Economic Commission for Europe**Inland Transport Committee****World Forum for Harmonization of Vehicle Regulations****Working Party on Passive Safety****Fifty-eight session**

Geneva, 8-11 December 2015

Regulation No. 16 (Safety-belts)**Proposal for Supplement 7 to the 06 series of amendments to Regulation No. 16 (Safety-belts)****Submitted by the expert from the European Association of Automotive Suppliers ***

Figure 2

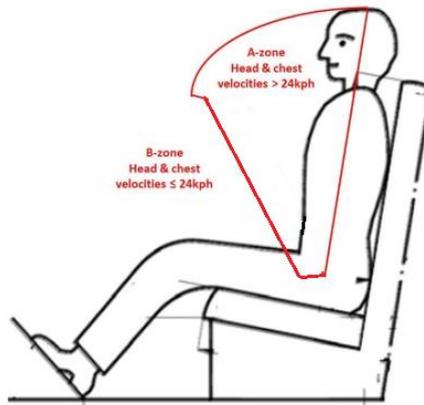
- "12.1. In case a restraint system has been granted/refused/extended/withdrawn ², those can be used for all vehicles compatible with the following dimensional conditions: no interior part in a quoted A-zone as shown below (figure 2):

Figure 1

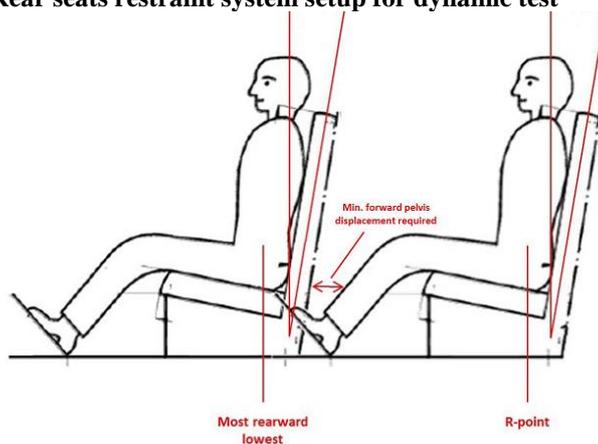
7.7.1.6.2. **For rear seats: For any testing position of rear seated occupants, the position of the tested seat, shall be considered as positioned to the seats R-Point position and its seat back angle positioned as close as possible to 10° if adjustable, derived from the 3-D H point machine.**

The seat in front of a tested seat shall be adjusted to the most rearward and lowest position appropriate for any contact with the manikin installed on the rear seat, then shifted forward to ensure the minimal pelvis displacement of 80 mm or respective of 40 mm according to paragraph 6.4.1.3.2. and with a seat back angle at as close as possible to 10°, as derived from the 3-D H Point machine (Annex 19, Figure 1).

This can be proven with a contour on CAD or drawing. This measurement should be done with manikin to this regulation (Annex 7)."
